DOCUMENT NUMBER: MTN-0001C-17-NA
 APC: 470,481, 756
 ISSUE DATE: 01-2017
 EXPIRATION DATE: 31-12-2019
 Bulletin Type: Informational Only

Motorola Solutions Technical Notification (MTN)

TITLE: Premature low battery alert and/or battery shutdown with SRX2200BN / APX6000BN radios and NNTN8930A Batteries

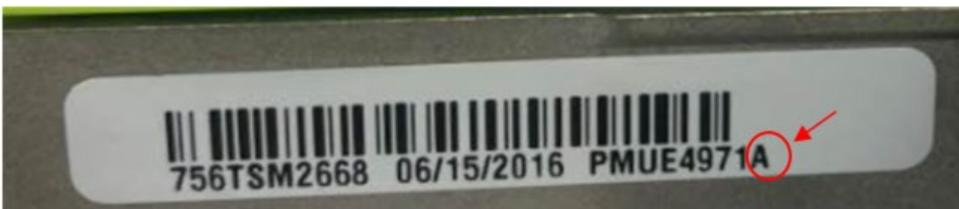
Customers can use one of the following batteries as a substitute.

- PMNN4547A IMPRES 2 Li-Ion battery, TIA 4950, 3100 mAh
- PMNN4573A IMPRES 2 Li-Ion battery, TIA 4950, 4800 mAh
- NNTN8921A IMPRES 1 Li-Ion battery, TIA 4950, 4500mAh
